**HARRISON COUNTY BOARD OF EDUCATION  
 HARRISON COUNTY, WEST VIRGINIA**

**BRIDGEPORT HIGH SCHOOL PRESS BOX  
 AND WEIGHT ROOM RENOVATIONS**

**ADDENDUM #2**

**THRASHER PROJECT #060-10117**

**CONSTRUCTION NOTES**

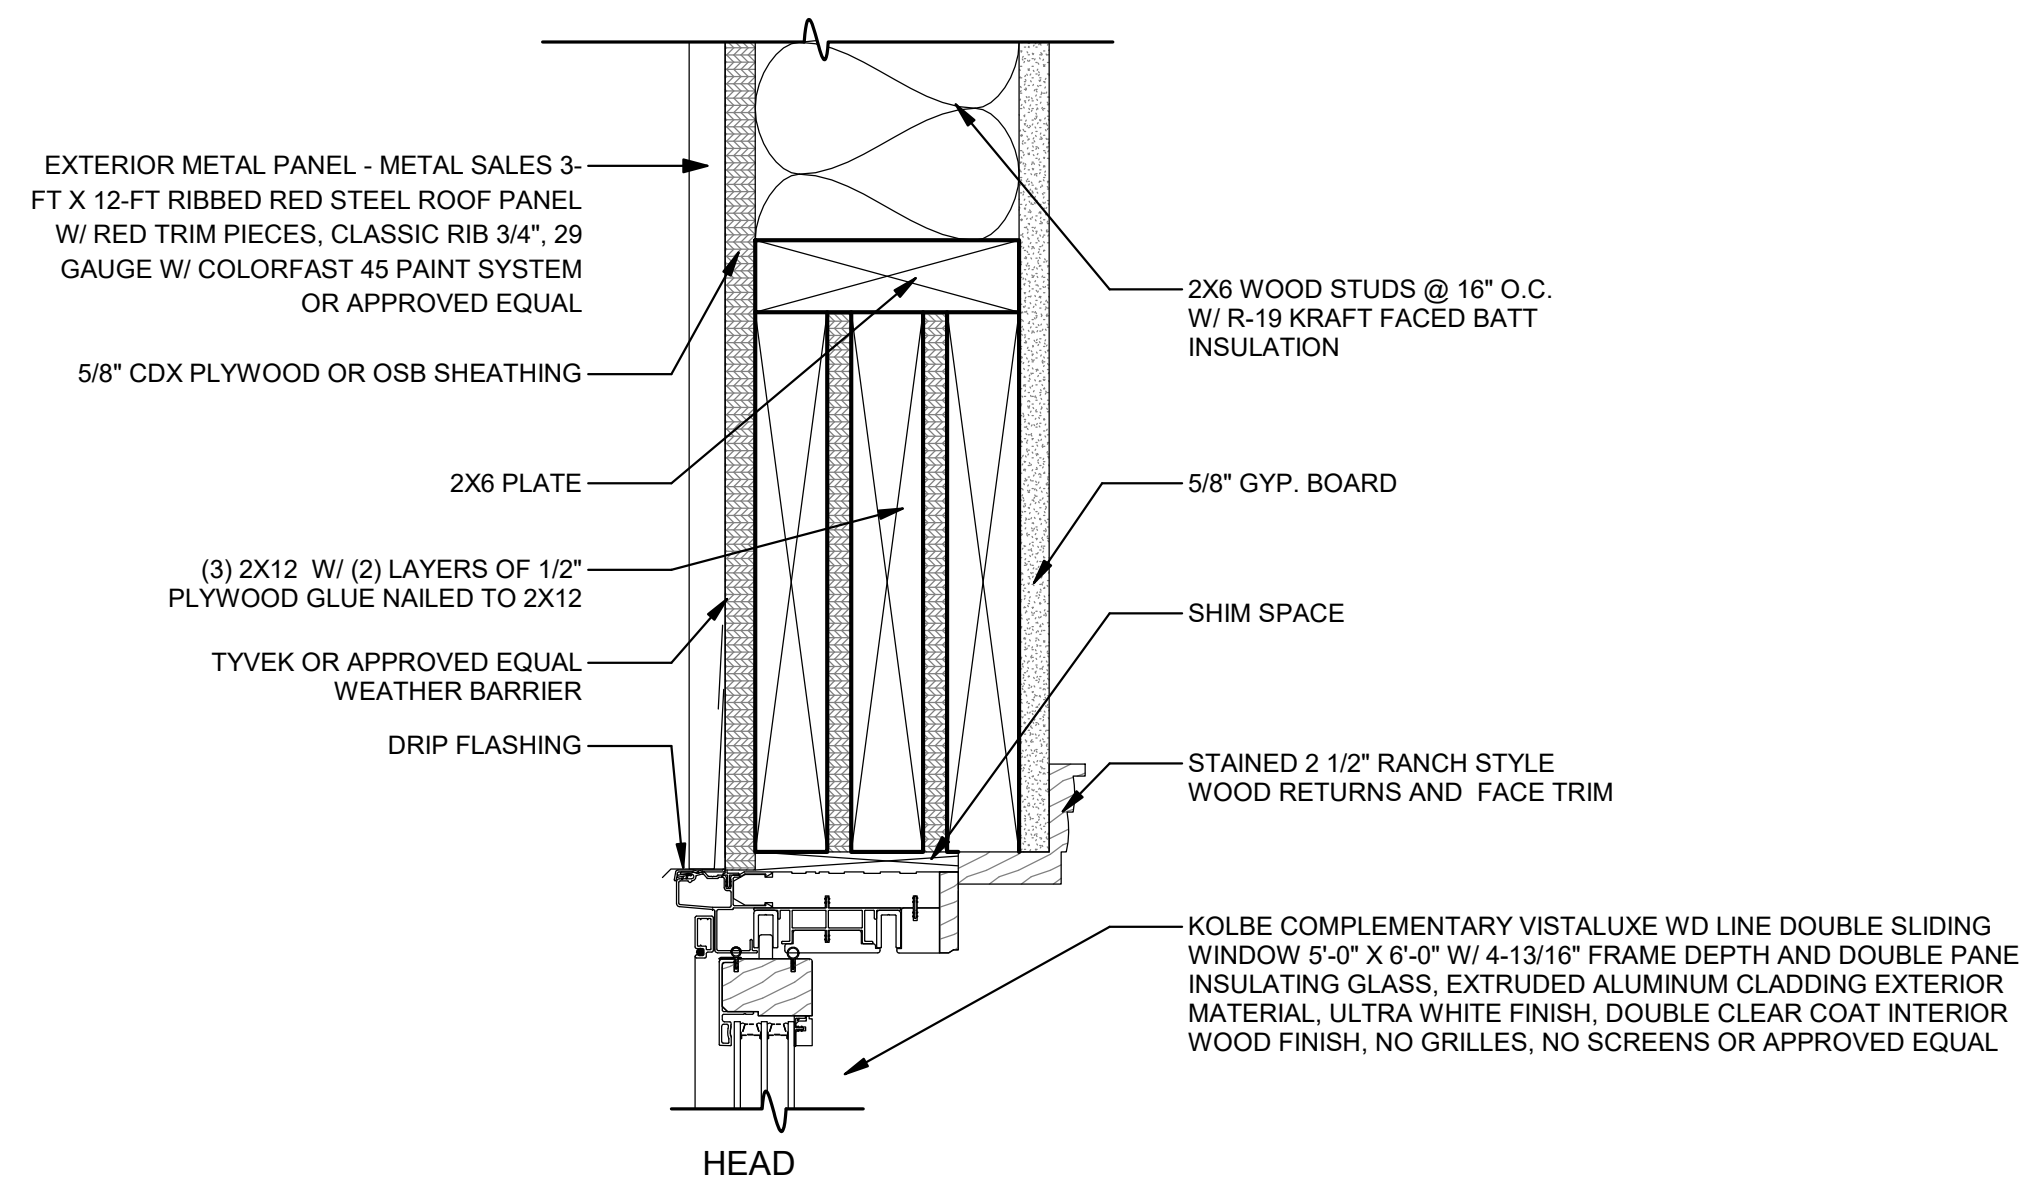
7. On A1.01 the details for the new walls in the press box show a wood framed wall, however in the general notes it calls out all new walls are to be metal framed. Which way should we figure these?

All new walls on the press box are to be wood framed walls.

1 WINDOW DETAILS  
A5.01R 3" = 1'-0"

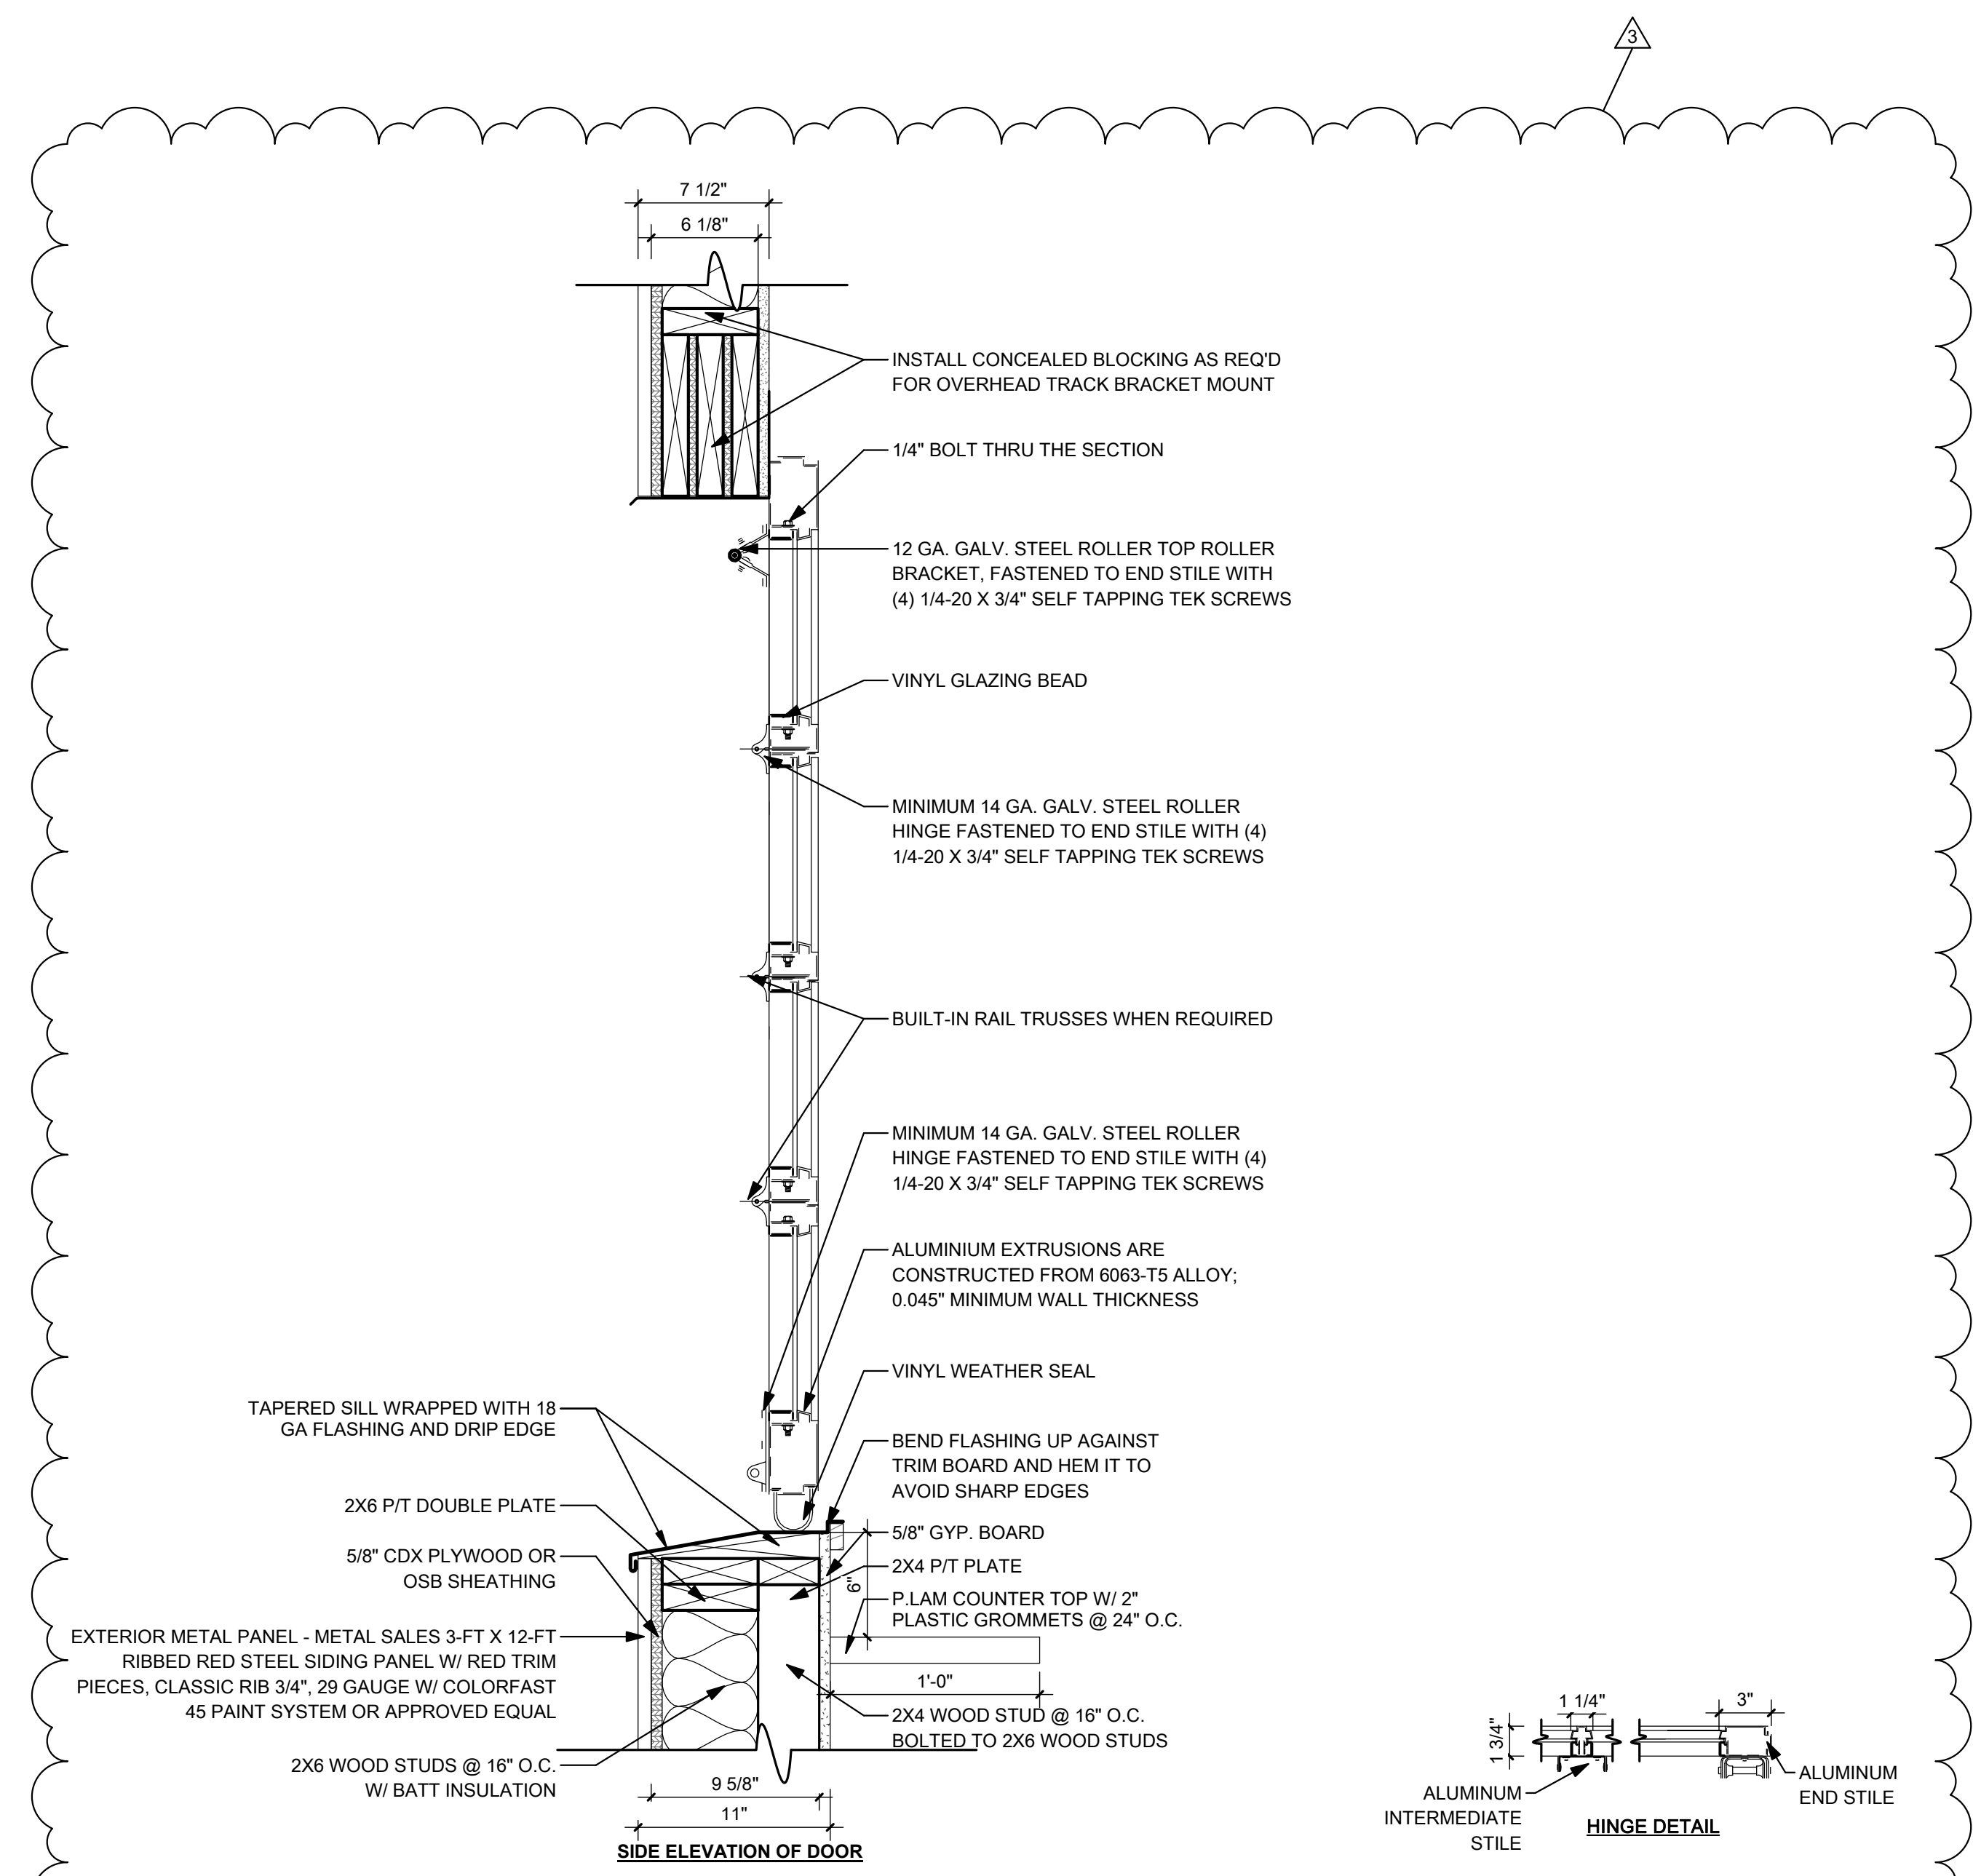
5. Will the vertical casing set directly onto the countertops so that the casing shown in sill detail on A5.01 will be eliminated?

See DRAWINGS #9. The countertop is to sit 6" below the sill to accommodate outlets above the countertop. Use 1/A5.02 COUNTERTOP DETAIL for brackets and fastening in relation to the countertop.

**1** DOOR DETAIL - EXT. HOLLOW METAL - MASONRY  
A-A6.01R 3" = 1'-0"

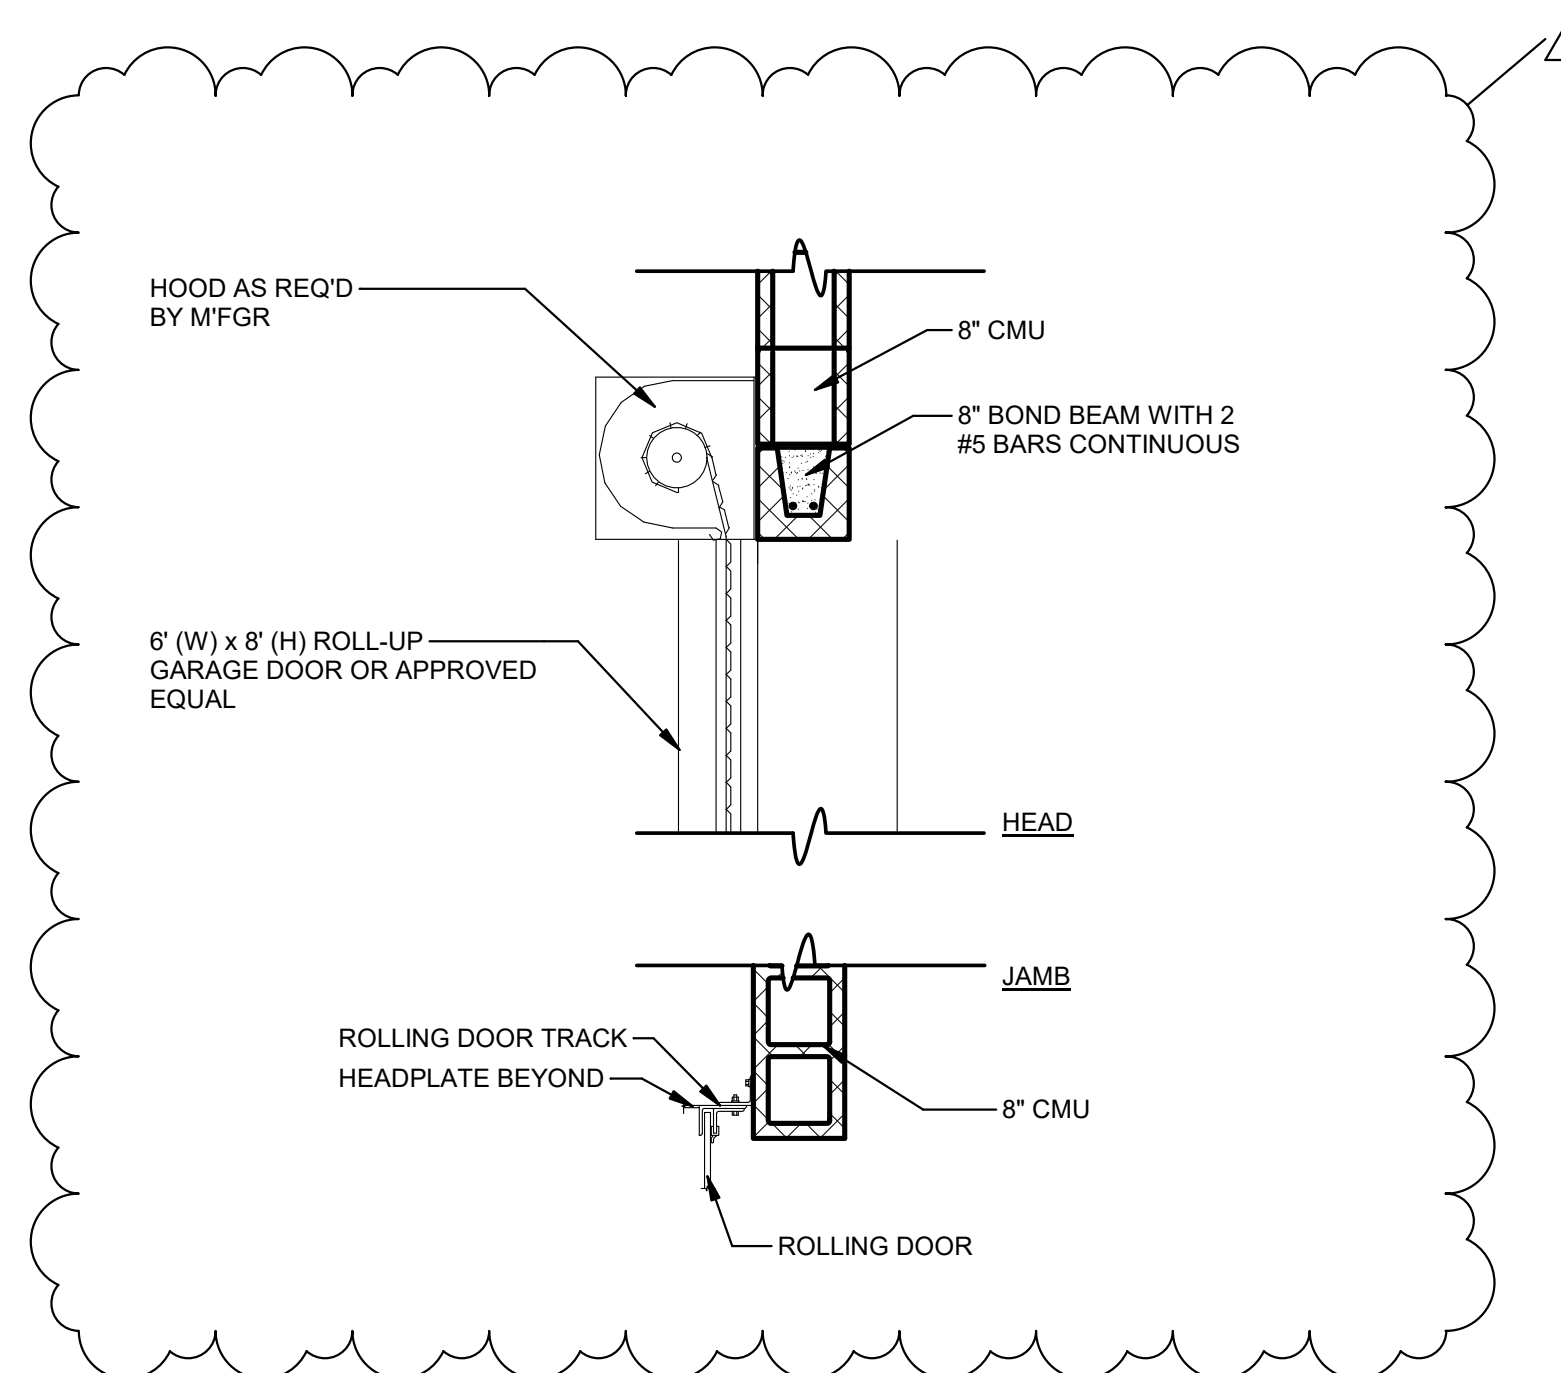
13. REPLACE A-A6.01 with A-A6.01R
14. ADD note on 2/A-A3.01 “INSTALL 2x4 BLOCKING OVER 3 TRUSSES MIN. FOR UNIT HEATER HANGER BOLTS”
